**PLANNING & ZONING**  
**February 06, 2025**  
**5:30 PM**  
**City Hall**

### **MILLS CITY PLANNING COMMISSION**

## **Lots 2A & 3A, Sage Addition**

**Vinich Development  
Commercial Development Plan**

# LIGHTING PLAN FOR VISION BEYOND BORDERS IN THE CITY OF MILLS NATRONA COUNTY, WYOMING

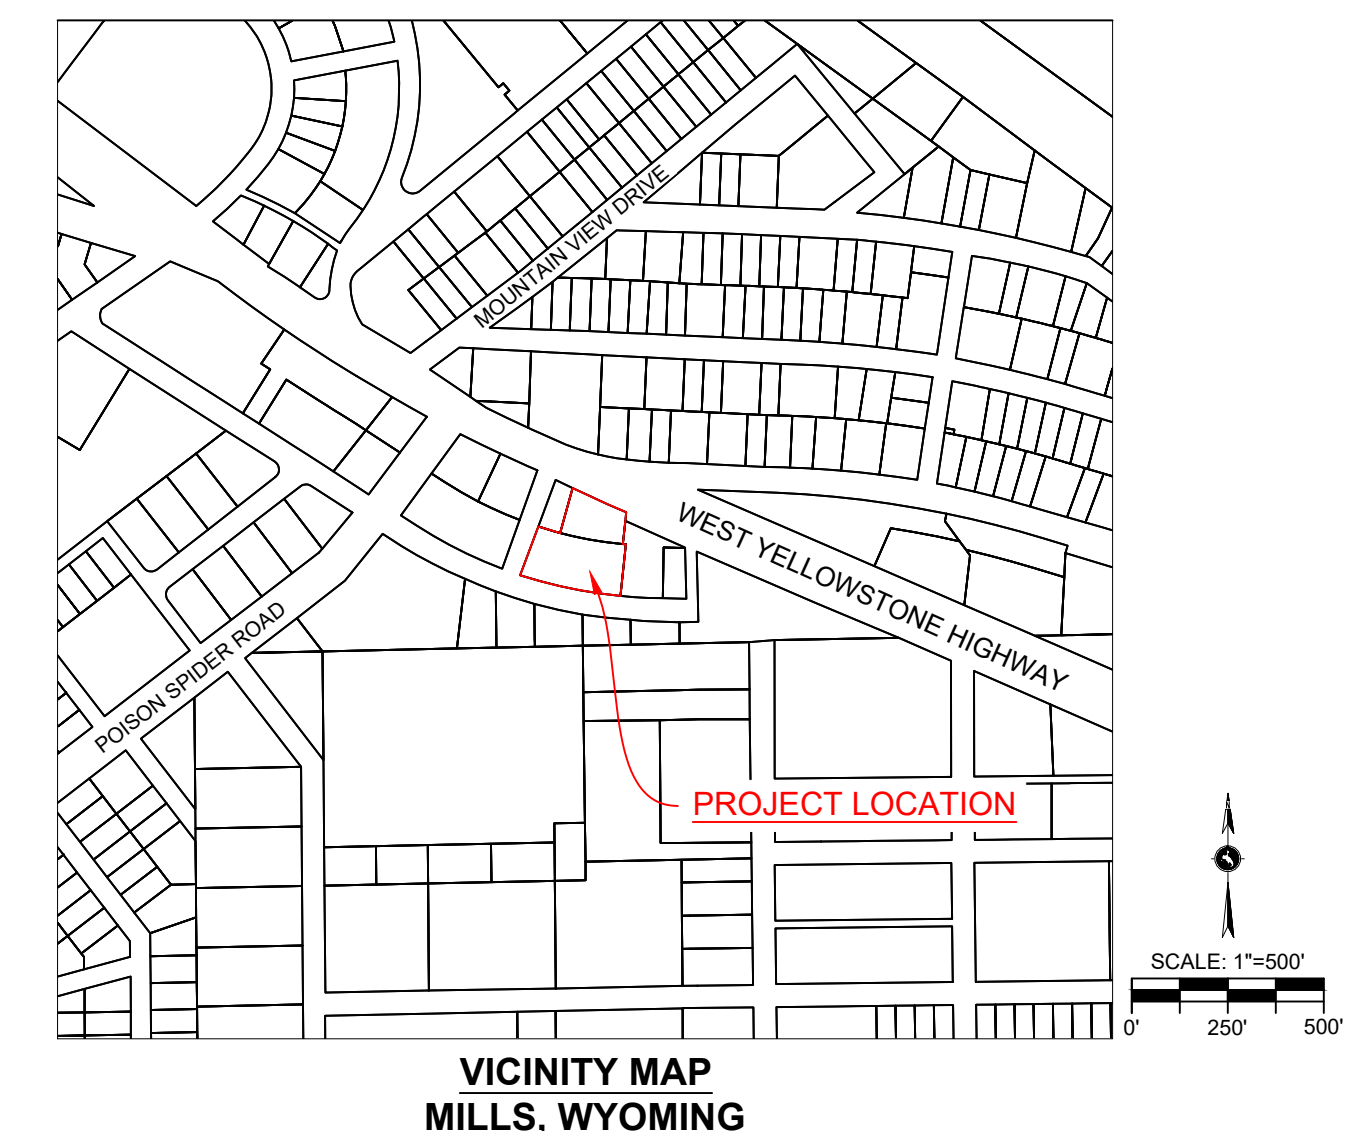
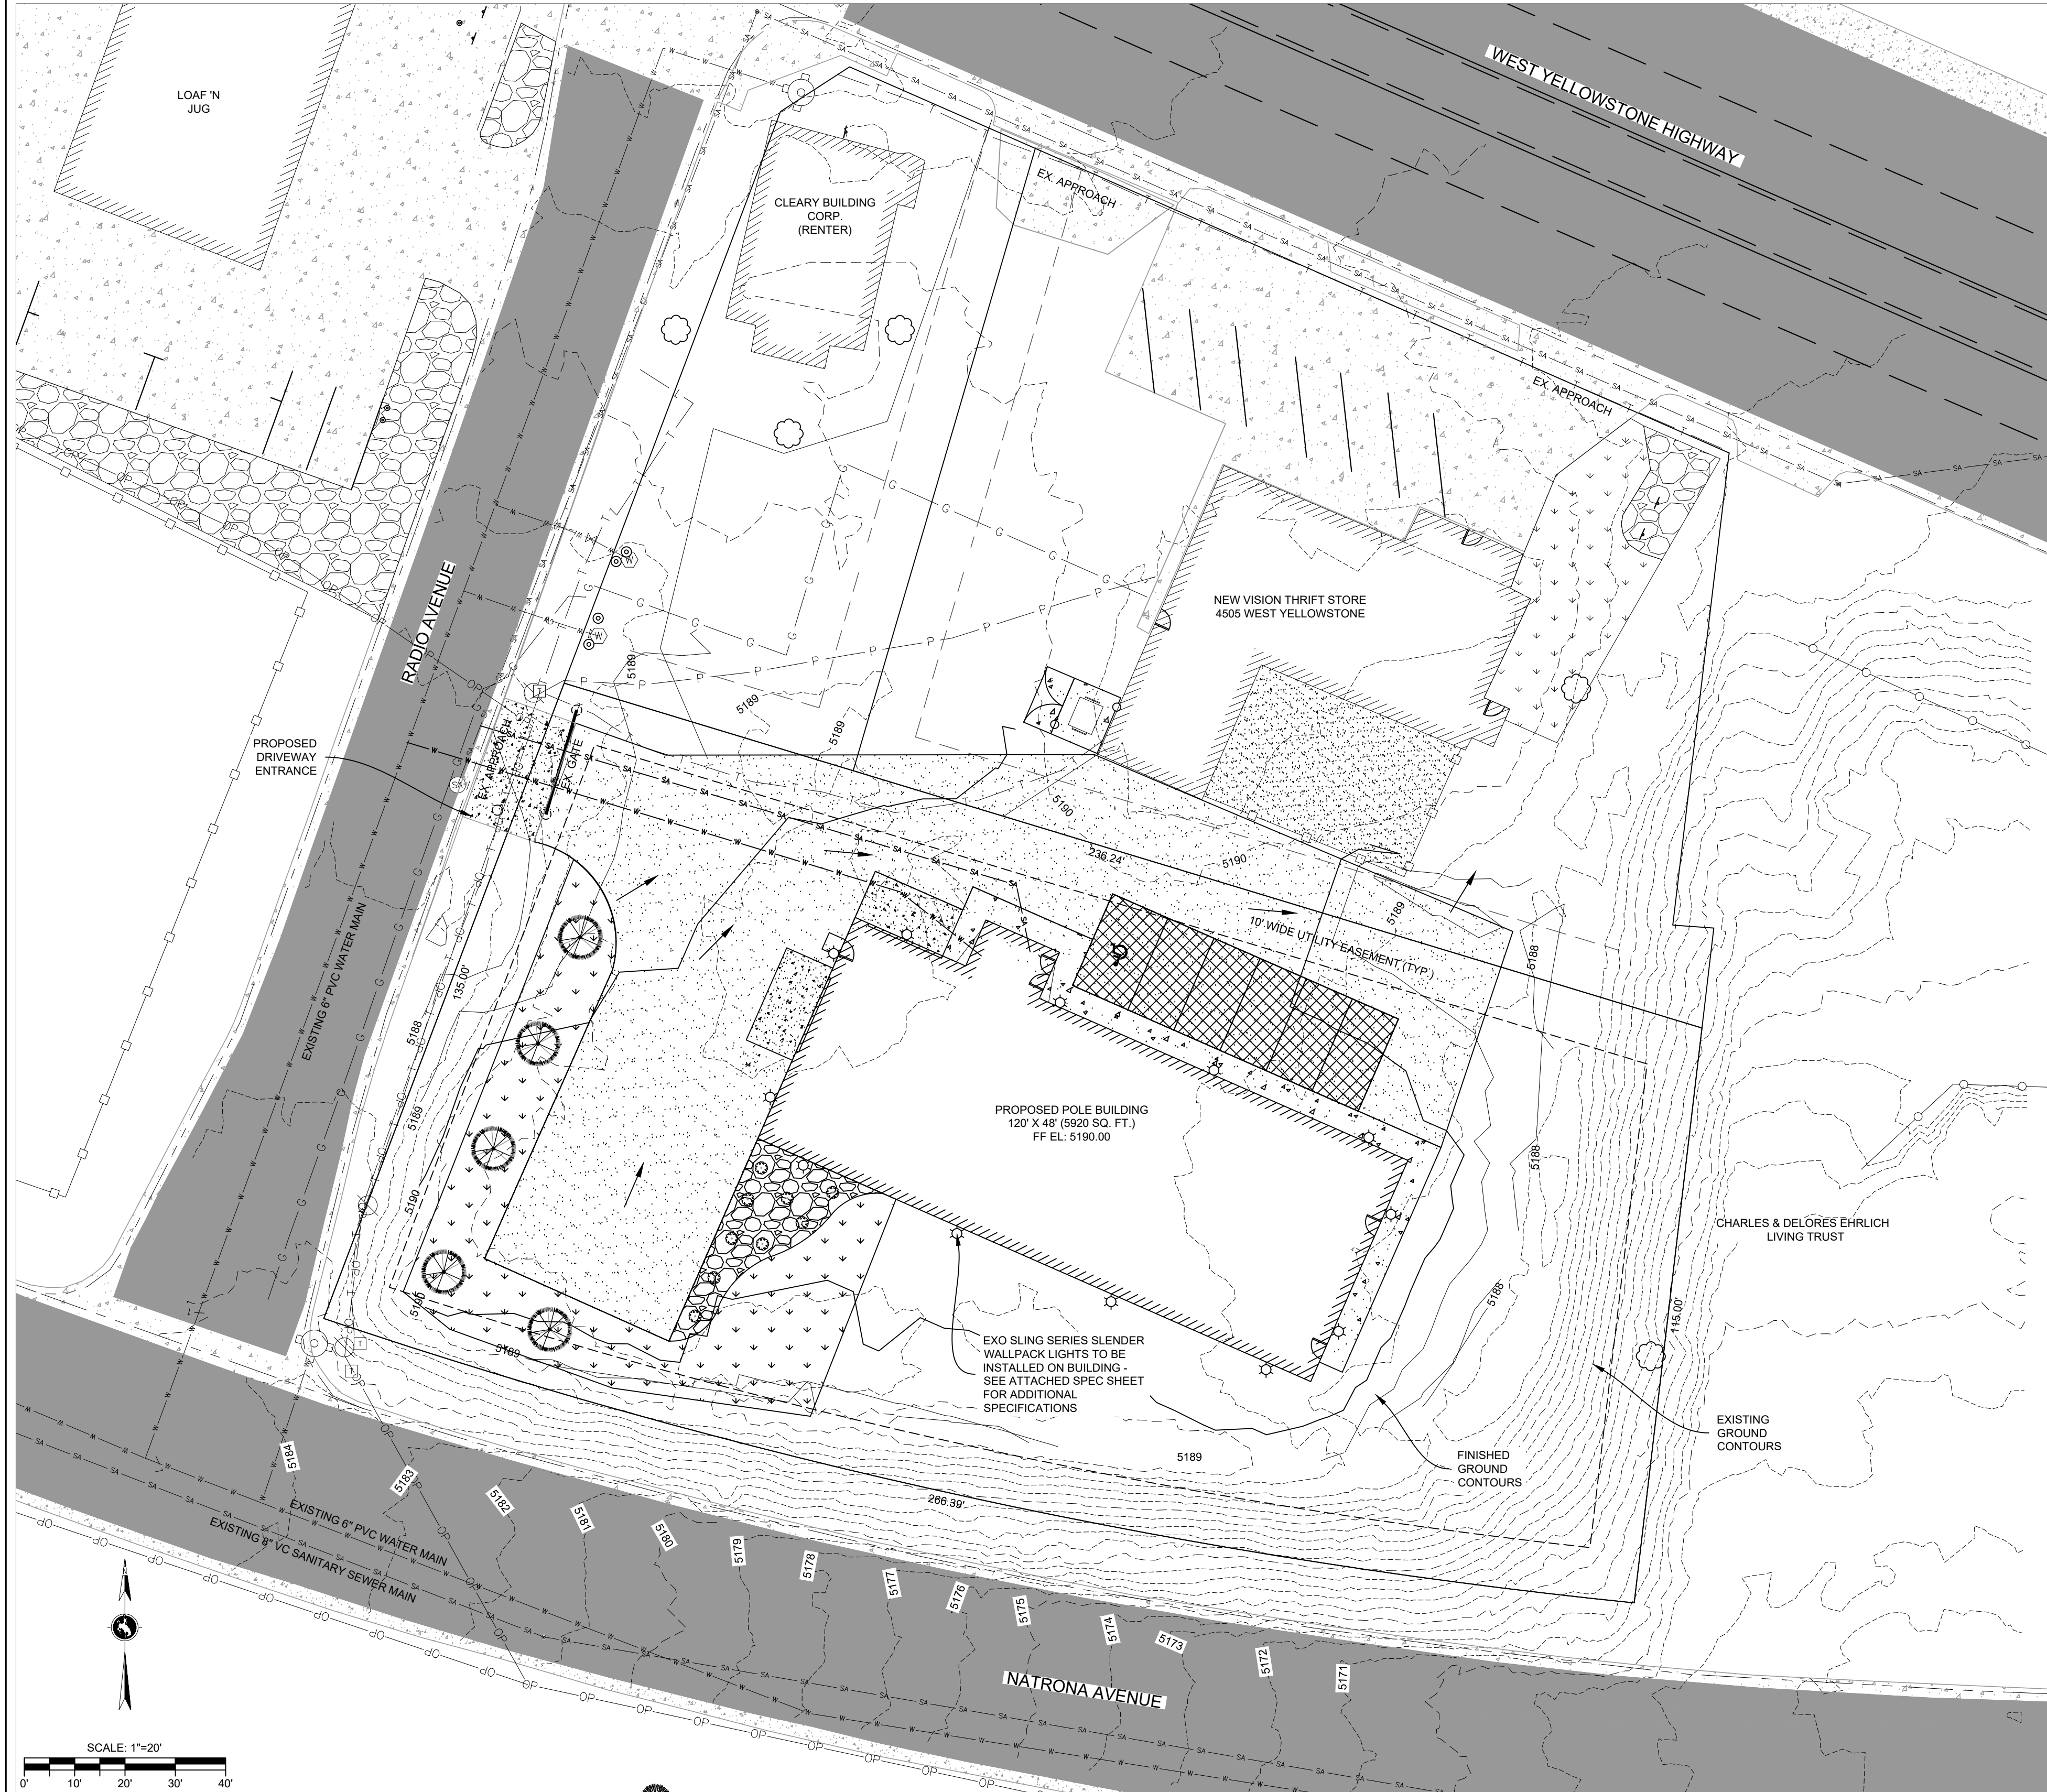
1. The previous application contained a conceptual exterior lighting plan. A more detailed exterior lighting plan has been provided with this submittal and appears to be in conformance with the LDRs.
